***ADDENDUM # 002***

**Our Lady of Fatima  
545 Baldoon Rd  
Chatham, ON**

**General Renovations and Addition for Mechanical  
Equipment  
Phase III**

**Project No. 619-CP1902**

1 **PART DEMOLITION PLAN PH 3**  
 ASK-001 1 : 150

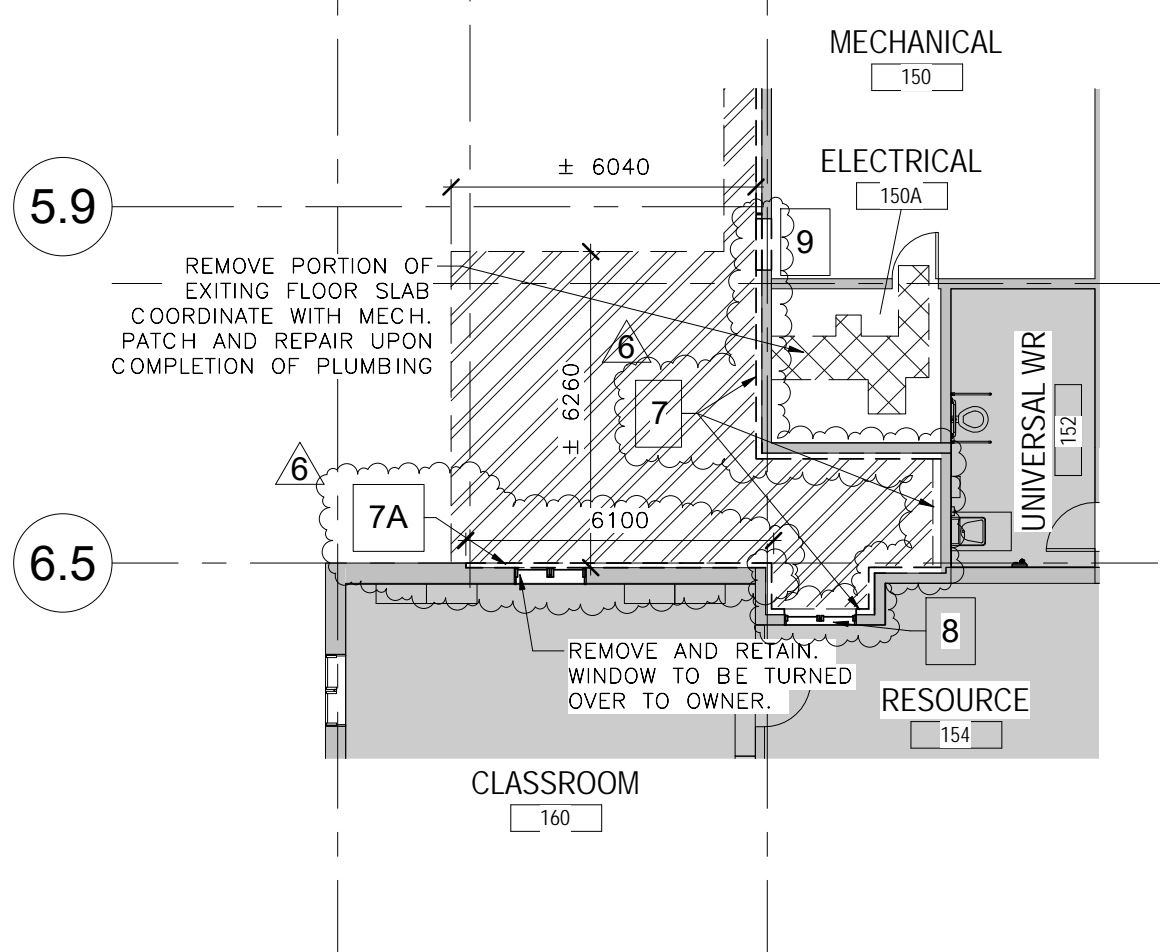
Is the existing brick veneer/metal siding, spray foam insulation etc. being removed inside the new mechanical room on grid line 6.5 and being replaced new metal stud and 90mm block wall (wall type IW3.4) to U/S of new roof deck?

Refer to ASK-001 and ASK-003 included in this addendum for details.

6  
**7A** REMOVE & DISPOSE OF EXISTING EXTERIOR BRICK AND RIGID METAL SIDING BACK TO EXISTING INSULATION. BLOCK STRUCTURE TO REMAIN. MAKE READY FOR NEW MASONRY.

**REVISED ADDITION ROOF FRAMING PLAN**

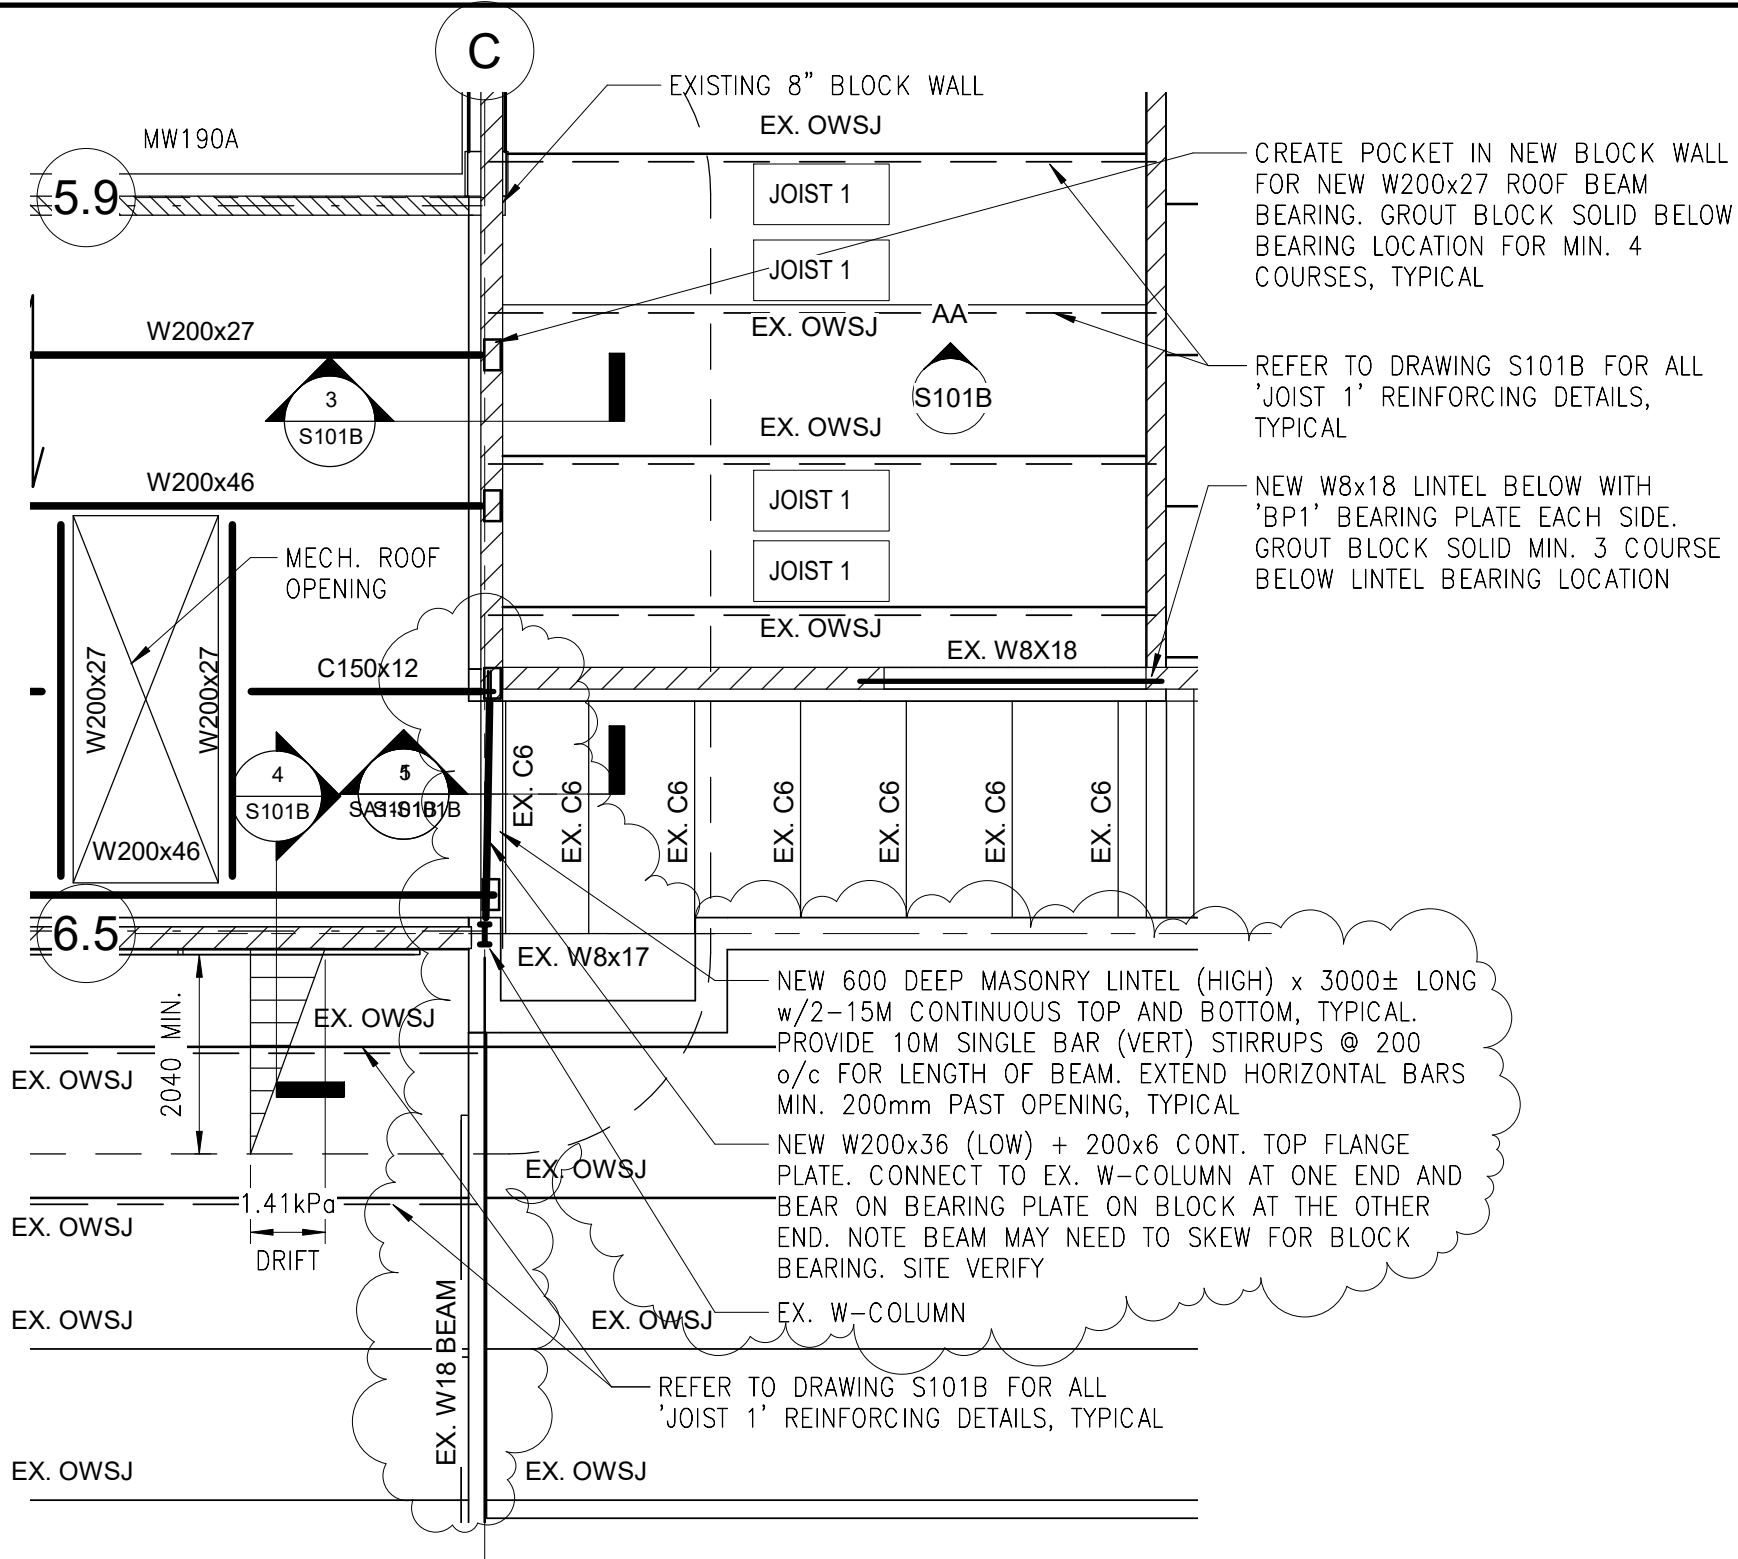
1. Refer to Drawing S101 – New Addition Roof Framing Plan
  - a) Revise framing plan as clouded in attached sketch SA1-S101.

CREATE POCKET IN NEW BLOCK WALL FOR NEW W200x27 ROOF BEAM BEARING. GROUT BLOCK SOLID BELOW BEARING LOCATION FOR MIN. 4 COURSES, TYPICAL

NEW W8x18 LINTEL BELOW WITH 'BP1' BEARING PLATE EACH SIDE. GROUT BLOCK SOLID MIN. 3 COURSE BELOW LINTEL BEARING LOCATION

NEW 600 DEEP MASONRY LINTEL (HIGH) x 3000± LONG w/2-15M CONTINUOUS TOP AND BOTTOM, TYPICAL. PROVIDE 10M SINGLE BAR (VERT) STIRRUPS @ 200 o/c FOR LENGTH OF BEAM. EXTEND HORIZONTAL BARS MIN. 200mm PAST OPENING, TYPICAL

NEW W200x36 (LOW) + 200x6 CONT. TOP FLANGE PLATE. CONNECT TO EX. W-COLUMN AT ONE END AND BEAR ON BEARING PLATE ON BLOCK AT THE OTHER END. NOTE BEAM MAY NEED TO SKEW FOR BLOCK BEARING. SITE VERIFY

DRAWING	<b>REVISED SECTION 5</b>	
	OUR LADY OF FATIMA PHASE 3 RENEWAL

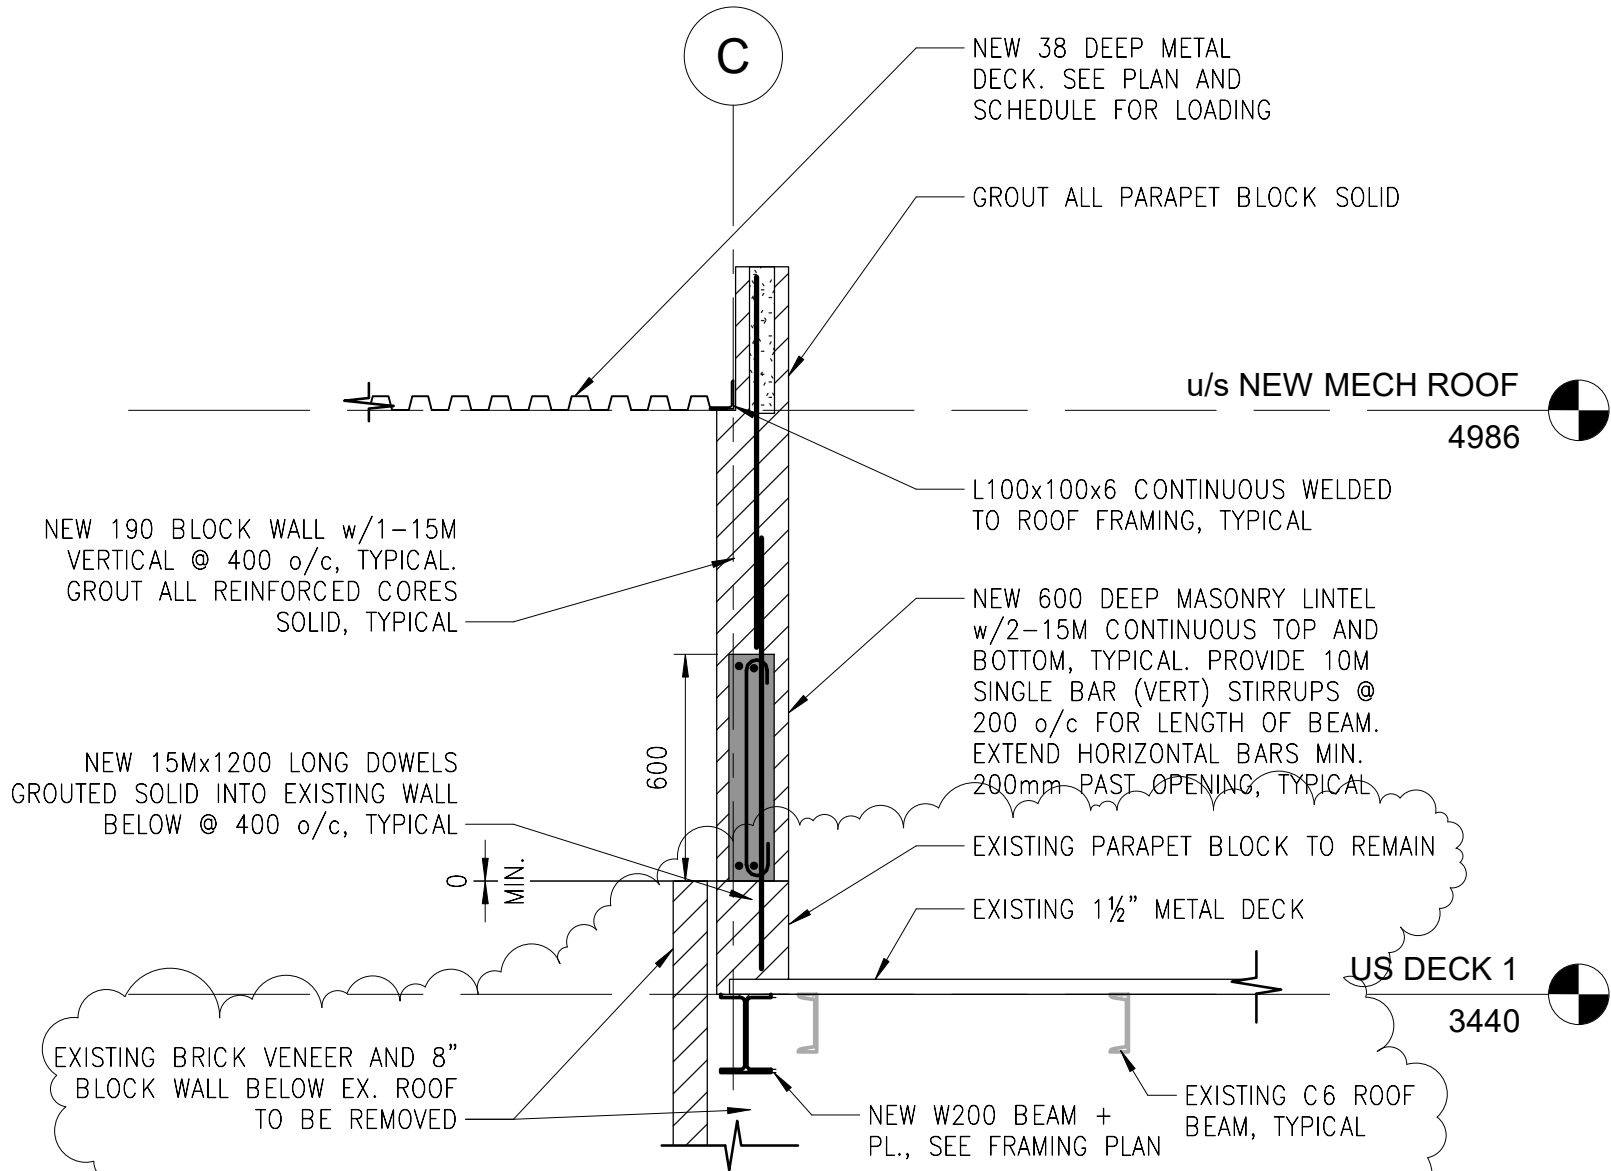
Refer to detail 5 on S101B – is a new steel beam required in order to support new 190 mm block being install above?

2. Refer to Drawing S101B – Sections
  - a) Revise Section 5 as clouded in attached sketch SA1-S101B.

NEW 190 BLOCK WALL w/1-15M VERTICAL @ 400 o/c, TYPICAL. GROUT ALL REINFORCED CORES SOLID, TYPICAL

NEW 15x1200 LONG DOWELS GROUTED SOLID INTO EXISTING WALL BELOW @ 400 o/c, TYPICAL

NEW 600 DEEP MASONRY LINTEL w/2-15M CONTINUOUS TOP AND BOTTOM, TYPICAL. PROVIDE 10M SINGLE BAR (VERT) STIRRUPS @ 200 o/c FOR LENGTH OF BEAM. EXTEND HORIZONTAL BARS MIN. 200mm PAST OPENING, TYPICAL

NEW W200 BEAM TO BE INSTALLED BEFORE NEW BLOCK IS CONSTRUCTED ABOVE. CONTRACTOR TO SHORE EXISTING ROOF DECK & PARAPET AS REQUIRED TO INSTALL W200

SHEET No.  
**P3-SE1**

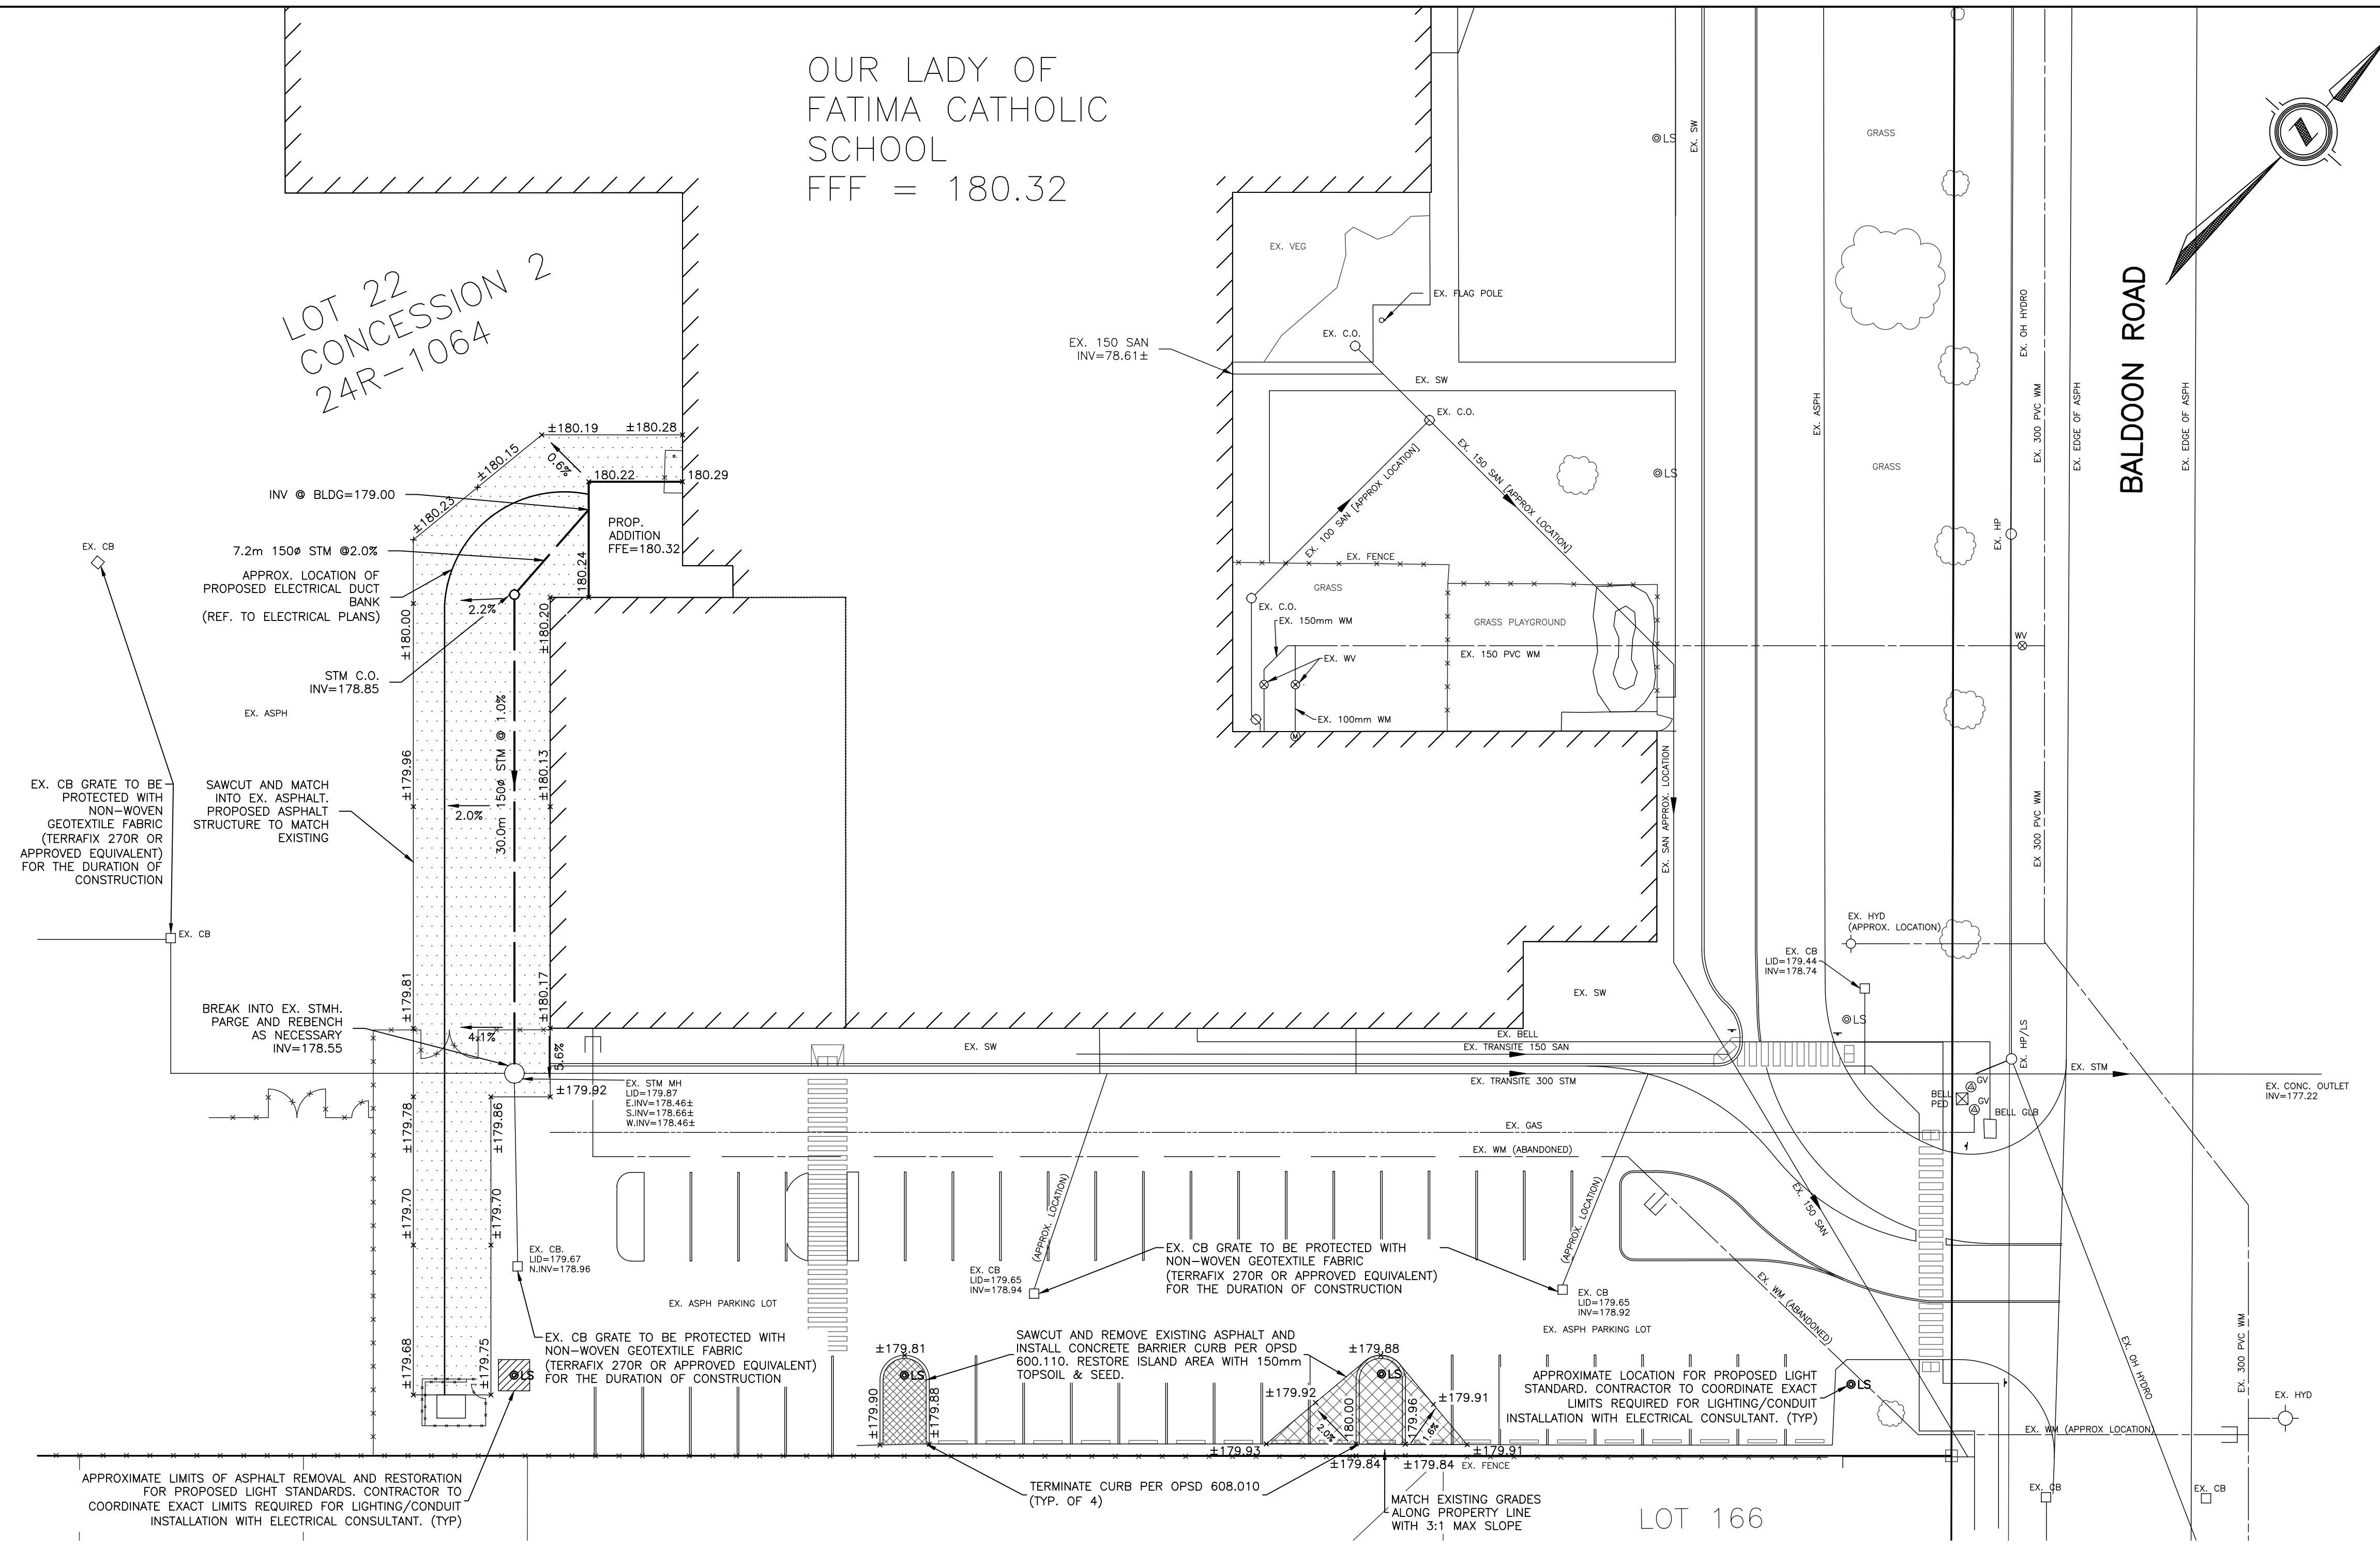
Drawing A010 issued with addendum 1 indicates new islands in the parking lot and to refer to civil drawings. Civil drawings do not show any islands. Can you confirm if there are new islands and provide details?

Refer to revised Civil Engineering Drawings issued with this addendum #002.

1. Refer to attached drawings P3-SE1 and P3-SE2 that completely replace previously issued drawings. **2 Page(s)**
